**KNOXVILLE HISTORIC ZONING COMMISSION  
STAFF REPORT - CERTIFICATE OF APPROPRIATENESS APPLICATION**

**PROPERTY ADDRESS:** 1019 Eleanor St  
**DISTRICT:** Fourth and Gill H-1

**FILE NO.:** 8-I-16-HZ

**MEETING DATE:** 8/18/2016

### Knoxville – 1917 – Sheet 76

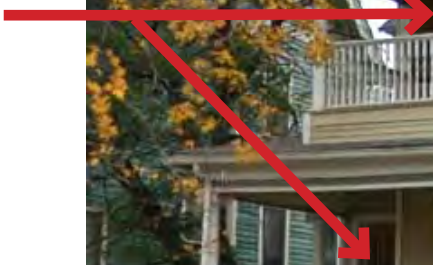
3. The window to replace the vinyl window at the lower rear level of the house will be a wooden SDL 2/2 double-hung window.
4. It appears that the first and second-level porch spaces have been altered from the original configuration of the house. The 1917 Sanborn map indicates that there was a one-story rear portion, but the current one-story rear portion appears to be smaller. The one-story rear porch is now longer extant. The upper level recess that is proposed to be filled in could be original or partially original.

1917 Sanborn Map indicating 1019 Eleanor as 1119 Eleanor. The porch is shown wrapping around to the south. A one-story addition and a one-story porch that are no longer extant are indicated in the rear.

Staff recommends approval of the proposal with the condition that a trim piece equal to the existing corner board be retained in the location of the right-hand side of the upper-level rear recess to indicate where it was originally located.

**FRONT OVERVIEW**

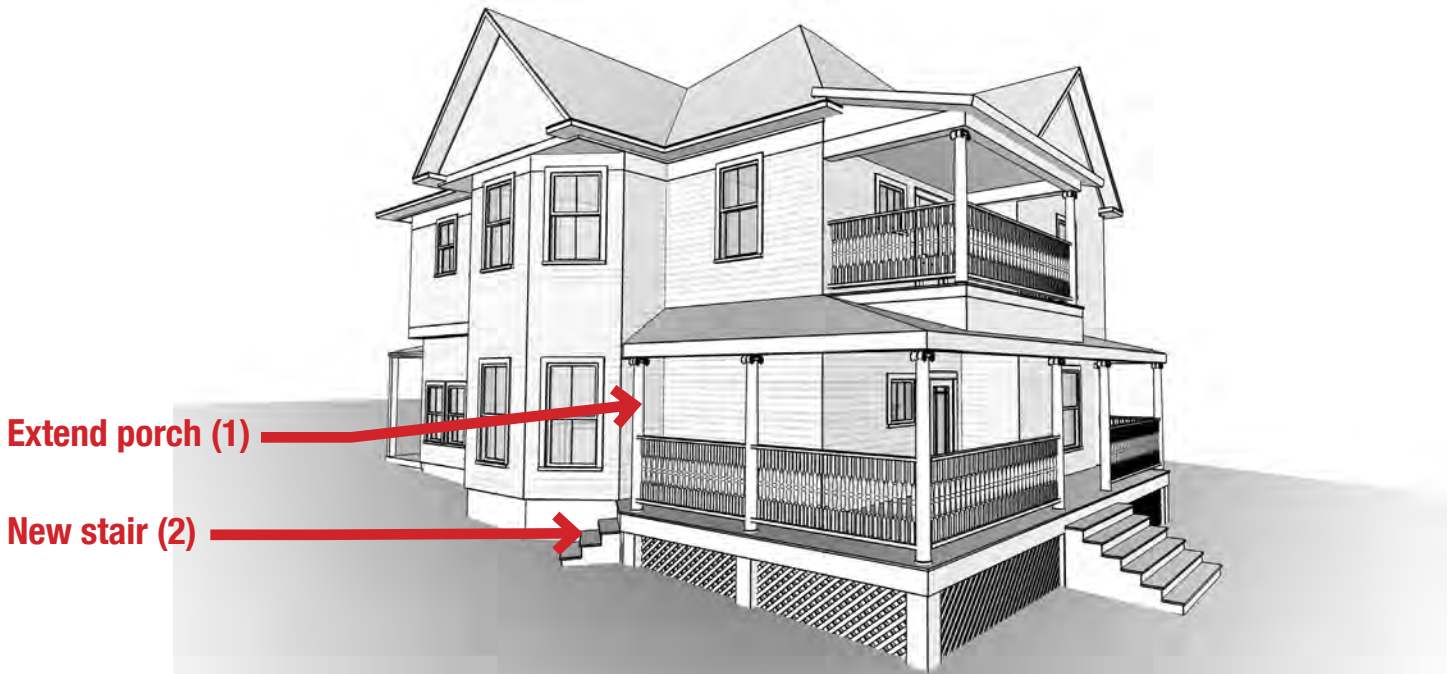
- 1** Remove non-original, partially open-air staircase between the front porch and the upper porch. Staircase will be replaced with new interior stair. Patch, repair, or provide new wood siding where stair and doorways are removed. Original porch beam at top of wall will be preserved. A new column with scamozzi capital and new wood railing will be built to match the existing porch columns and railings.
- 2** Remove exterior concrete basement stairs, wood door at bottom of stairs, and small metal roof above stairs. Remnants of the original interior basement stair were discovered and a new stair will be constructed in that location. All damaged siding to be patched and repaired in-kind. Add wood steps from the front porch to the side yard in this location.

**3,4** Remove non-original doors to former apartments upstairs and down. Openings will be filled with wood siding to match existing.

1. The restoration of the front porch will be based on documentation provided by physical evidence as the design guidelines recommend.
2. Staff believes the installation of the twin double-hung windows in wood in place of the single window will not compromise any important character-defining elements of the house. The early or original window will be reused as the guidelines recommend.

## BACK OVERVIEW

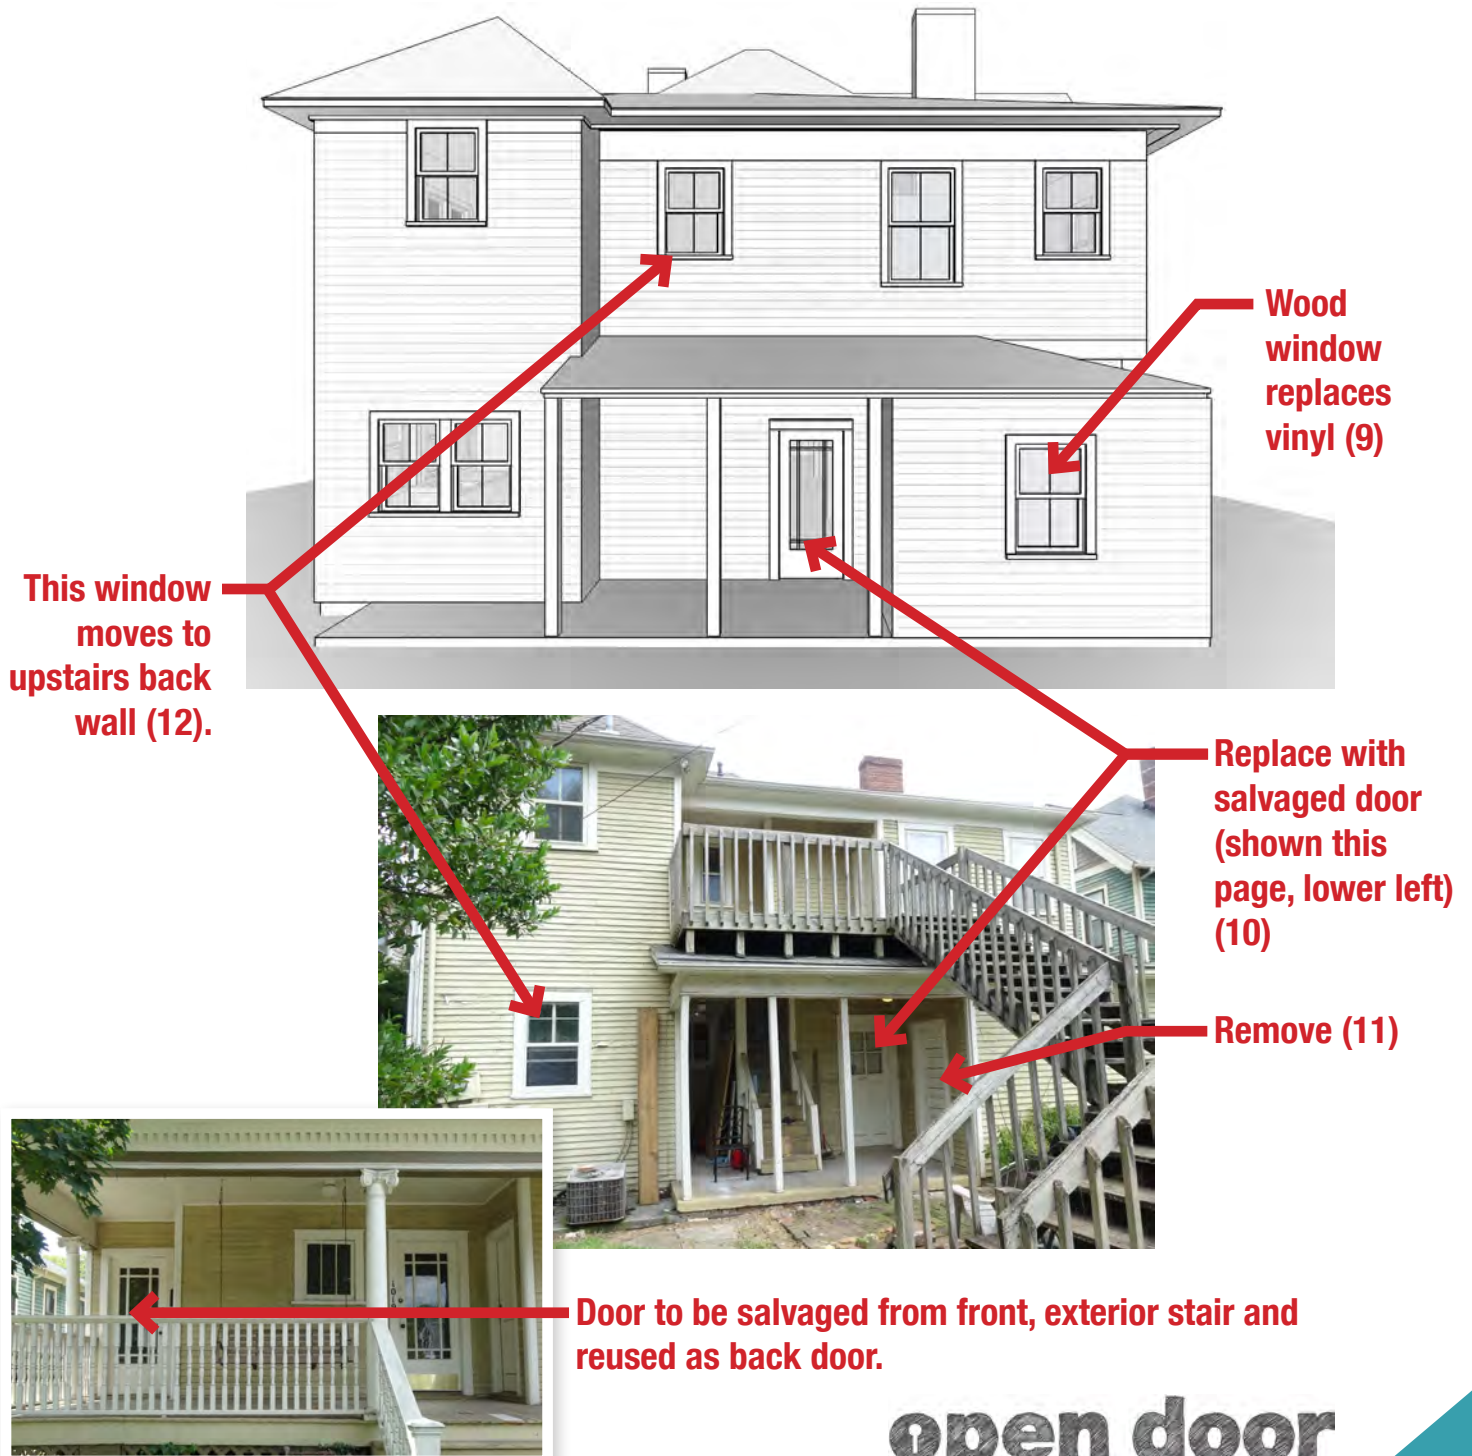
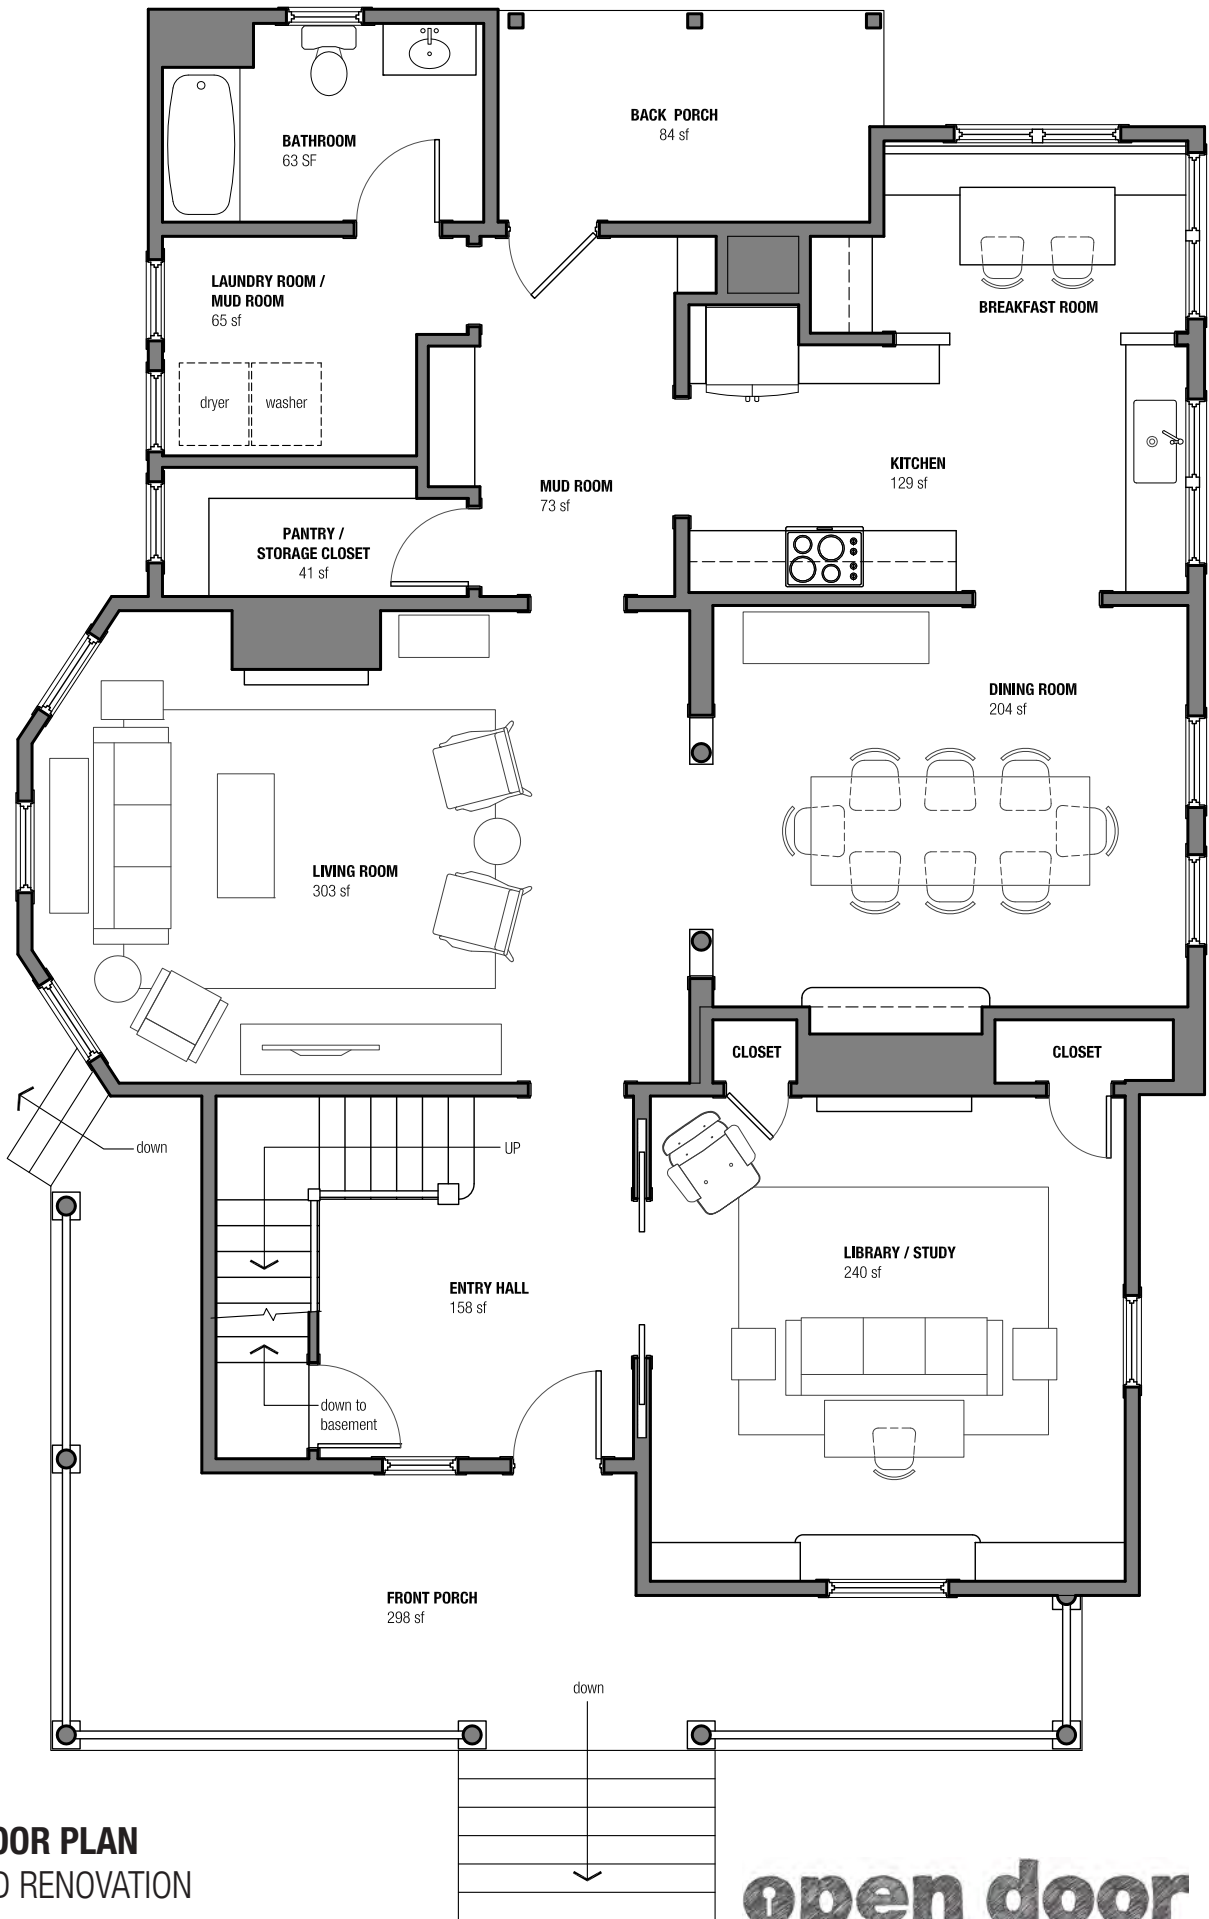
**5,6** Partially enclose porches, upstairs and down. New walls will have wood siding to match existing.

**7,8** (7) Remove upper deck and staircase - patch porch roof below as required. (8) Remove non-functioning, partial staircase downstairs.

**9** Remove single, double hung, vinyl window facing the alley and replace with new wood, double hung, 2-over-2 window to match original windows.

**10** Replace existing back door with door salvaged from front, exterior stair (matches front door).

**11** Remove non-functioning door. Opening will be filled with wood siding to match existing.

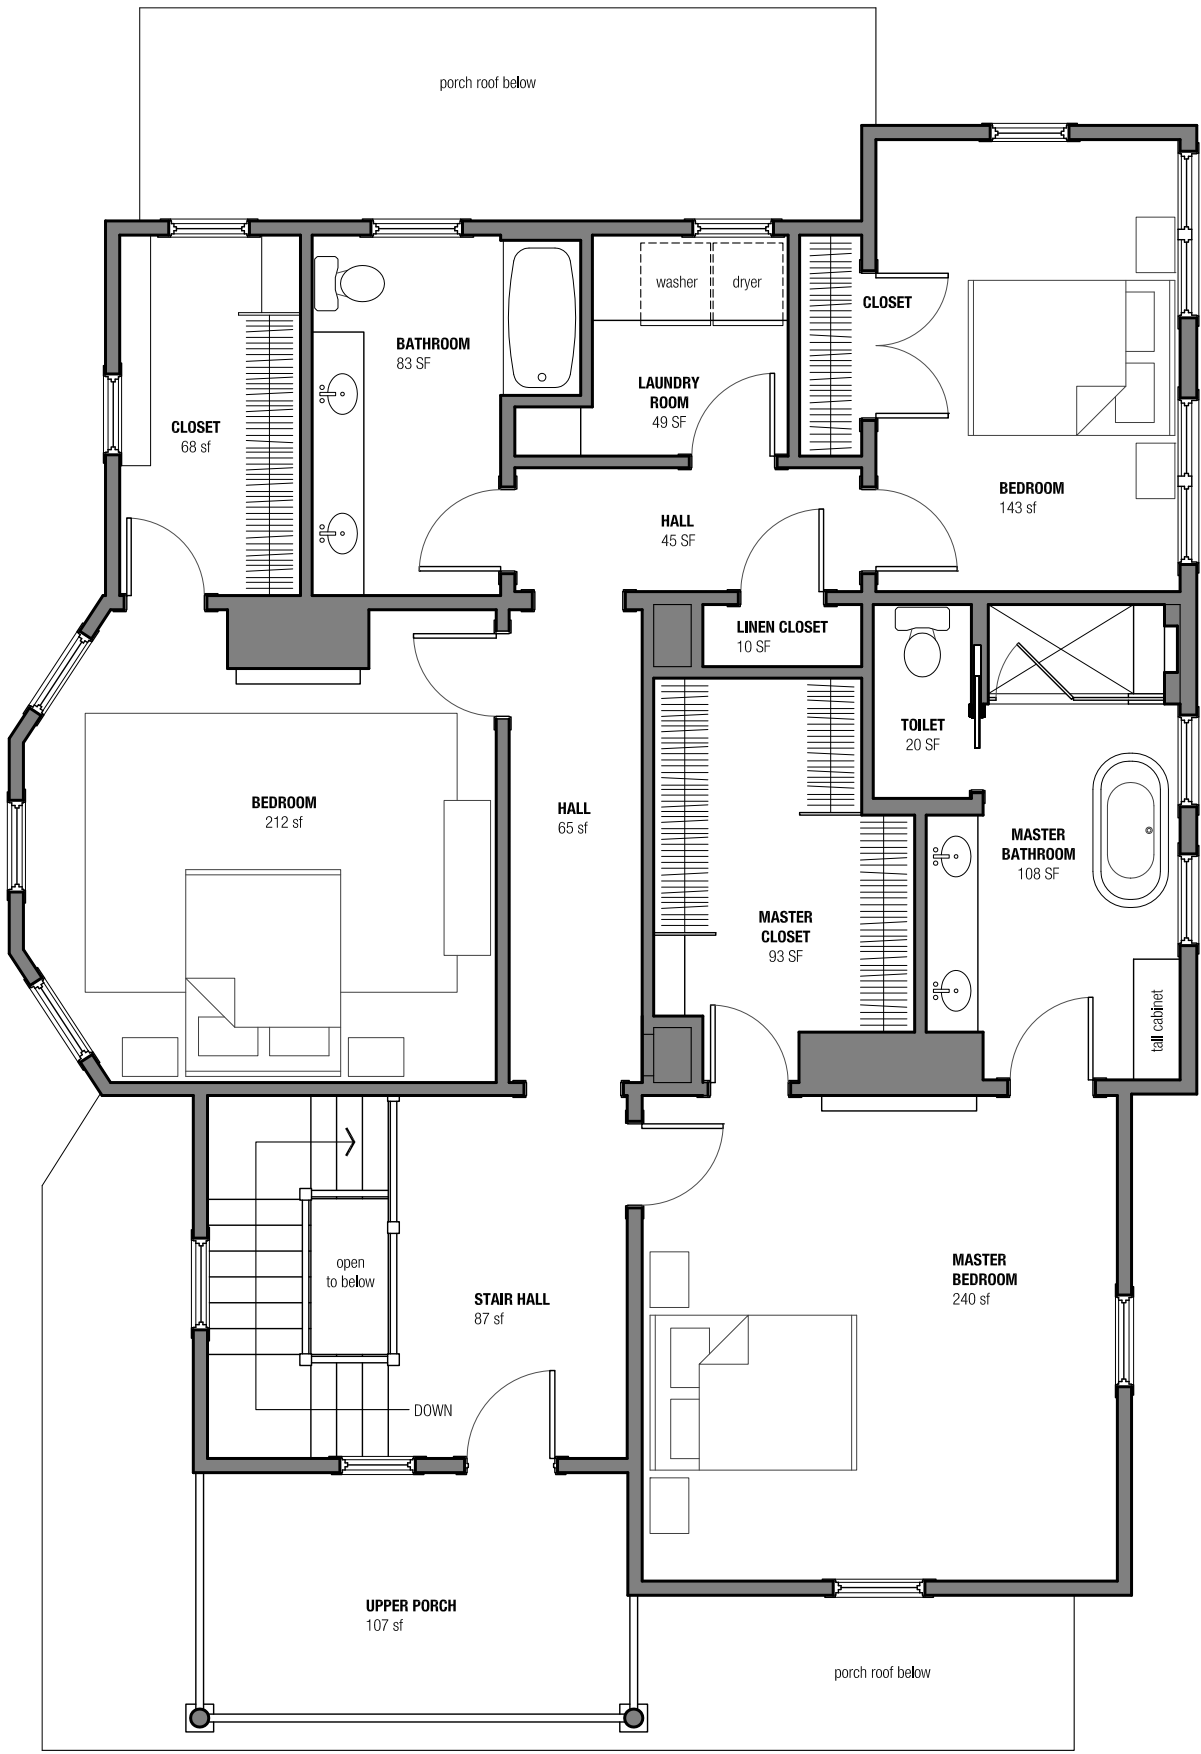
**12** Remove single, double hung, 2-over-2 window facing the alley and replace with new pair of wood, double hung, 2-over-2 windows. Move single window from downstairs to upstairs back wall.
